ANSTY GARDEN COMMUNITY,

DESIGNERS RESPONSE

REPORT REF NO. 2207280-R19

- 1.6 The following drawing have been prepared to incorporate the findings of the RSA:
- **ACE Drawing 2207280-007B** – Proposed Cycle Connections A272 / Bolney Road / B2036

Drawing Title:
**PROPOSED CYCLE CONNECTIONS
 A272 / BOLNEY ROAD / B2036**

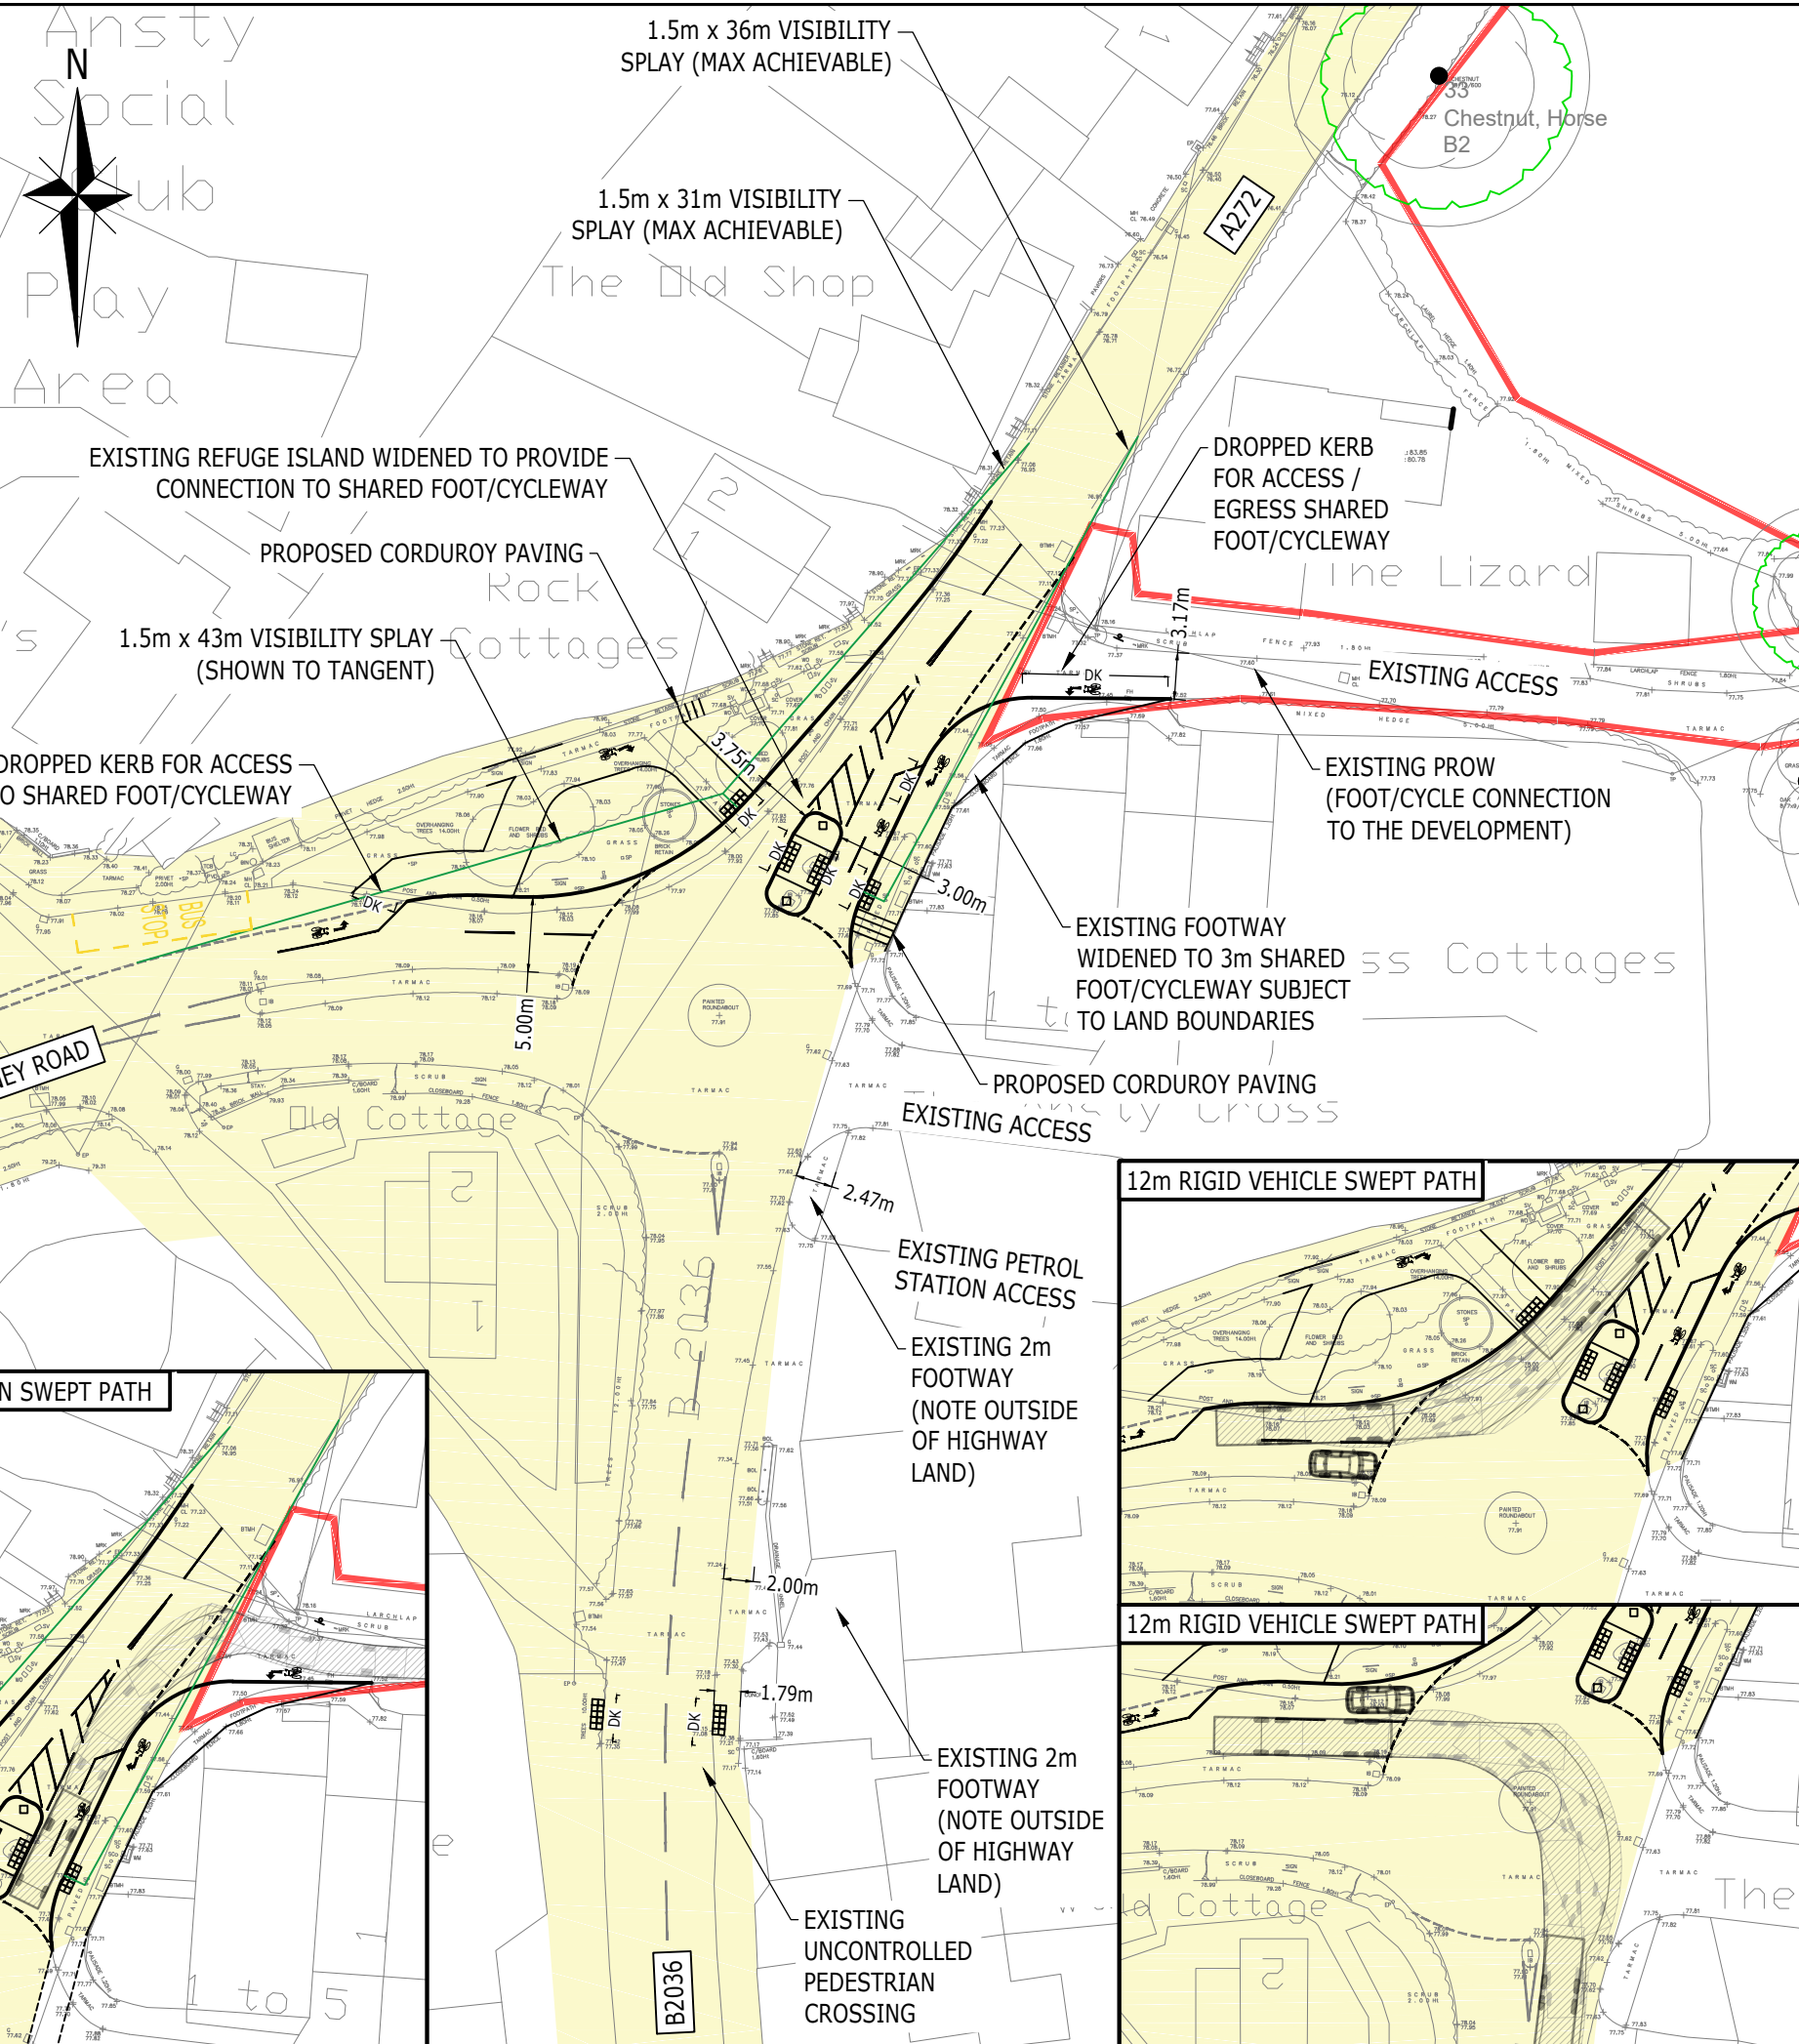
B	UPDATED FOLLOWING STAGE 1 RSA COMMENTS	DV	DV	DH	17.10.23
A	UPDATED TO ALLOW 5m ENTRY WIDTH	DV	DV	DH	22.09.23
Rev	Description	Drn	Chk	App	Date

<p>3.4.1 Restricted visibility could lead to vehicle to cyclist collisions.</p> <p>No details relating to the cyclist / traffic intervisibility splays at the cycle street junction with Bolney Road have been provided for assessment. There is concern that the hedgerow in the eastern splay on the</p>	<p>It is recommended that the hedgerow should be cut back and periodically maintained to retain visibility.</p>	<p>The street in question is to be kept as per the existing arrangements. The concern is an existing situation that is not being amended as part of the proposals. This has been made clear on ACE Drawing 2207280-007B.</p>

Drawing Title:
**PROPOSED CYCLE CONNECTIONS
A272 / BOLNEY ROAD / B2036**

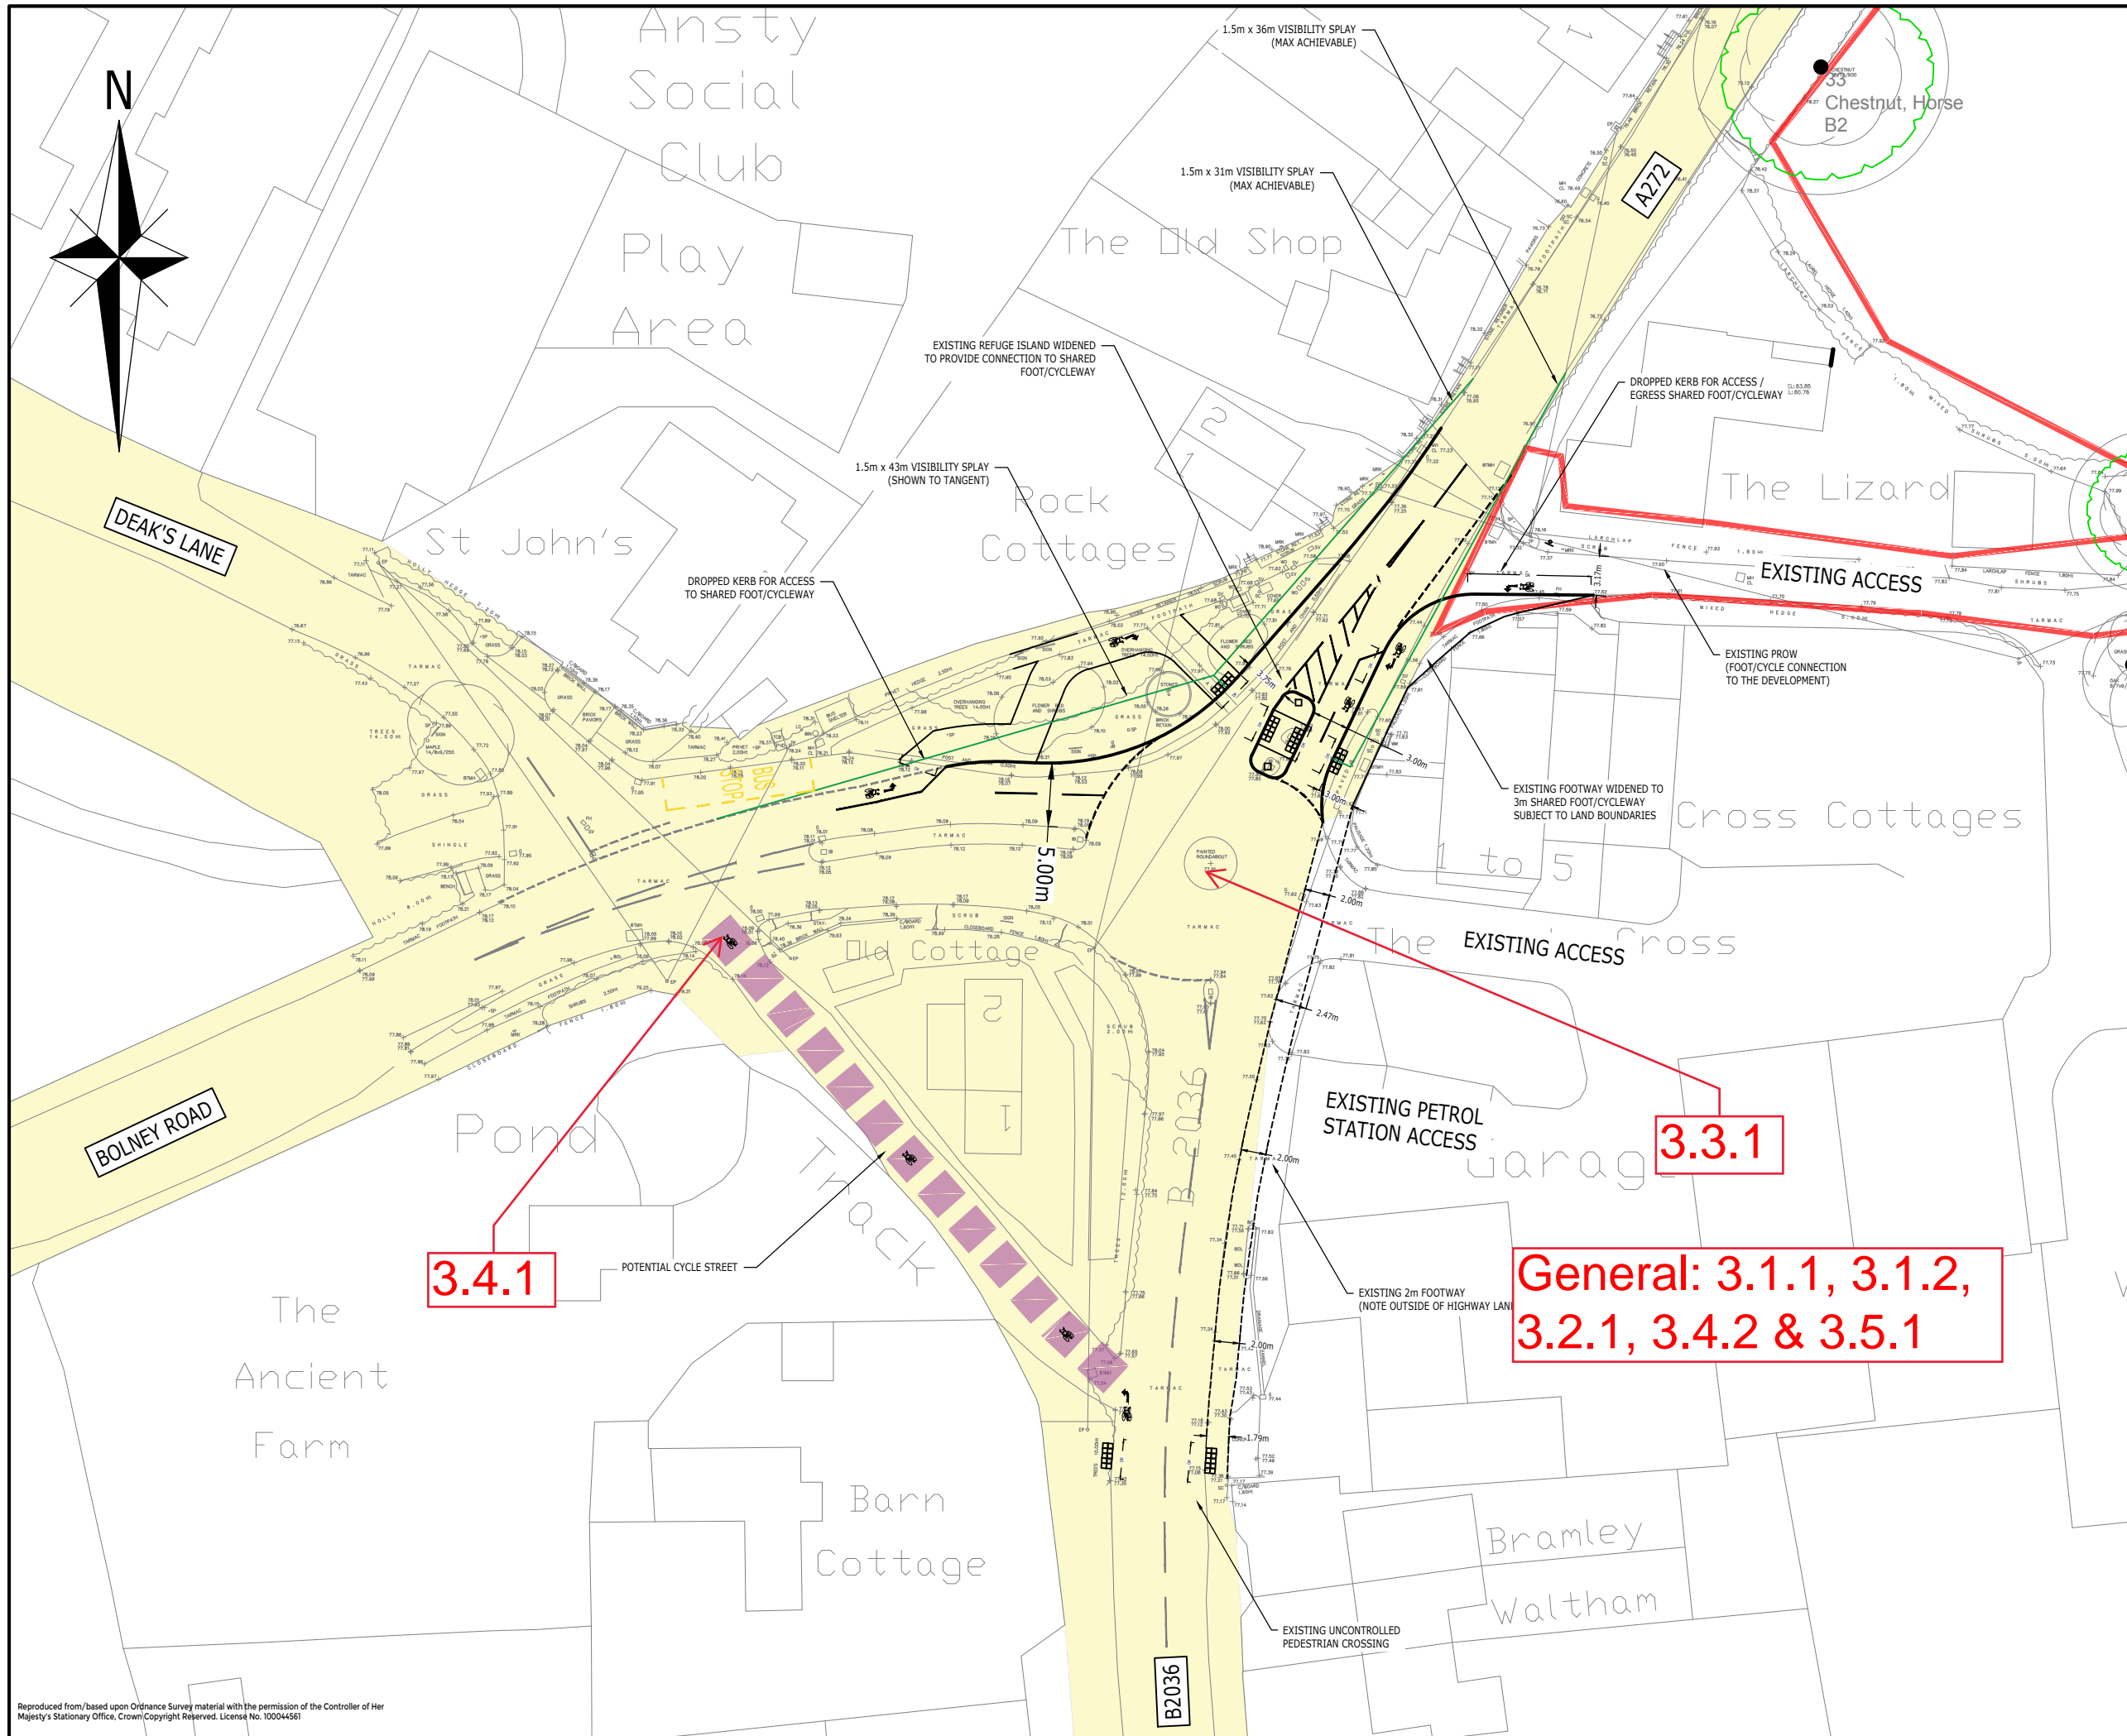
Summary: Insufficient construction details could lead to overshoot or rear end shunt collisions.

The proposals do not include the introduction of anti-skid surfacing or detail the Polished Stone Value (PSV) to be used on the approaches to the roundabout and surfacing as part of the scheme. Surfacing with an insufficient PSV could lead to overshoot or rear end shunt collisions.

It is recommended that high friction surfacing should be provided on all the approaches to the roundabout and that the PSV of all surfacing should be provided for assessment at Stage 2 Safety Audit.

Summary: Ponding of surface water could lead to loss of control collisions.

Kerblines are being amended as part of these proposals, where at this early stage no details of carriageway drainage have been provided for assessment; ponding on the carriageway or water moving across the carriageway at the junction could lead to loss of control collisions, particularly in wet / icy conditions.

It is recommended that drainage details should be provided at Stage 2 Safety Audit.

Summary: Vehicles entering the opposing carriageway at bend may lead to collisions with parked vehicles, side swipe collisions or vehicle to pedestrian collisions.

Summary: Insufficient capacity could lead to rear end shunt or side impact collisions.

No details of expected flows and the capacity of the roundabout have been provided for assessment. Insufficient capacity could lead to congestion, where excessive queuing at the roundabout could lead to driver frustration and the use of inappropriate gaps, further unbalanced flows could lead to entry problems on to the roundabout. This may lead to rear end shunt or side impact collisions.

It is recommended that the roundabout should operate without excessive queuing and with balanced flows and that an ARCADY or similar model should be provided for assessment.

Summary: Restricted visibility could lead to vehicle to cyclist collisions.

No details relating to the cyclist / traffic intervisibility splays at the cycle street junction with Bolney Road have been provided for assessment. There is concern that the hedgerow in the eastern splay on the southern side of the carriageway may restrict intervisibility. Restricted intervisibility could lead to vehicle to cyclist collisions.

It is recommended that the hedgerow should be cut back and periodically maintained to retain visibility.

Summary: Absence of tactile paving could lead to cyclist to pedestrian collisions.

It is recommended that paving details are provided are provided for assessment at Stage 2 Safety Audit.

Summary: Absence of vertical cyclist signage could lead to cyclist to pedestrian collisions.

It is recommended that signing details are provided are provided for assessment at Stage 2 Safety Audit.

RSA problem	RSA recommendation	Design Organisation response	Overseeing Organisation response	Agreed RSA action
<p>3.1.1 Insufficient construction details could lead to overshoot or rear end shunt collisions.</p> <p>The proposals do not include the introduction of anti-skid surfacing or detail the Polished Stone Value (PSV) to be used on the approaches to the roundabout and surfacing as part of the scheme. Surfacing with an insufficient PSV could lead to overshoot or rear end shunt collisions.</p>	<p>It is recommended that high friction surfacing should be provided on all the approaches to the roundabout and that the PSV of all surfacing should be provided for assessment at Stage 2 Safety Audit.</p>	<p>Details of PSV values and surfacing materials will be provided for Stage 2 Audit.</p>

<p>3.1.2 Ponding of surface water could lead to loss of control collisions.</p> <p>Kerblines are being amended as part of these proposals, where at this early stage no details of carriageway drainage have been provided for assessment; ponding on the carriageway or water moving across the carriageway at the junction could lead to loss of control collisions, particularly in wet / icy conditions.</p>	<p>It is recommended that drainage details should be provided at Stage 2 Safety Audit.</p>	<p>Drainage details will be provided for Stage 2 Audit.</p>		
<p>3.2.1 Vehicles entering the opposing carriageway at bend may lead to collisions with parked vehicles, side swipe collisions or vehicle to pedestrian collisions.</p> <p>Kerblines are being amended to accommodate the proposed scheme; however, no swept paths have been provided assessment. There is concern that larger vehicles such a refuse vehicle may not be able to undertake turning manoeuvres without entering the adjacent running lane or opposing carriageway or colliding with street furniture. Insufficient carriageway space could lead</p>	<p>It is recommended that the carriageway widths should be sufficient to ensure that all expected movements can be safely accommodated, where swept paths should be supplied for assessment.</p>	<p>Swept paths of a 12m rigid vehicle turning left from Bolney Road has been shown on ACE Drawing 2207280-007B. A box van sized vehicle has also been shown in either direction with no encroachment to opposing lanes etc.</p>

<p>to sideswipe collisions, or footway overrun and potential vehicle to pedestrian collisions, or collisions with the pedestrian refuge, and possible loss of control collisions.</p>				
<p>3.3.1 Insufficient capacity could lead to rear end shunt or side impact collisions.</p> <p>No details of expected flows and the capacity of the roundabout have been provided for assessment. Insufficient capacity could lead to congestion, where excessive queuing at the roundabout could lead to driver frustration and the use of inappropriate gaps, further unbalanced flows could lead to entry problems on to the roundabout. This may lead to rear end shunt or side impact collisions.</p>	<p>It is recommended that the roundabout should operate without excessive queuing and with balanced flows and that an ARCADY or similar model should be provided for assessment.</p>	<p>An ARCADY assessment has been undertaken and demonstrates that the junction operates with spare capacity in the Development Case scenario. The results are attached at Appendix C.</p>

<p>southern side of the carriageway may restrict intervisibility. Restricted intervisibility could lead to vehicle to cyclist collisions.</p>				
<p>3.4.2 Absence of tactile paving could lead to cyclist to pedestrian collisions.</p> <p>Shared footway / cycleways are proposed; however, at this early stage, no details have been provided on the tactile paving. Pedestrians may be unaware that the footway is a shared use route, which may lead to cyclist to pedestrian collisions.</p>	<p>It is recommended that paving details are provided for assessment at Stage 2 Safety Audit.</p>	<p>Tactile and corduroy paving is shown on ACE Drawing 2207280-007B. Further details will be provided for Stage 2 Safety Audit.</p>		
<p>3.5.1 Absence of vertical cyclist signage could lead to cyclist to pedestrian collisions.</p> <p>Shared footway / cycleways are proposed; however, at this early stage, no details have been provided on the vertical signage. Pedestrians may be unaware that the footway is a shared use route, which may lead to cyclist to pedestrian collisions.</p>	<p>It is recommended that signing details are provided for assessment at Stage 2 Safety Audit.</p>	<p>Signage to be in accordance with TSRGD and LTN1/20 standards noted on ACE Drawing 2207280-007B. Signage details will be provided for Stage 2 Safety Audit.</p>

- 3.1.1 Noted and accepted.
- 3.1.2 Noted and accepted.
- 3.2.1 Noted and accepted.
- 3.3.1 Noted and accepted.
- 3.4.1 Noted.
- 3.4.2 Noted and accepted.
- 3.5.1 Noted and accepted.
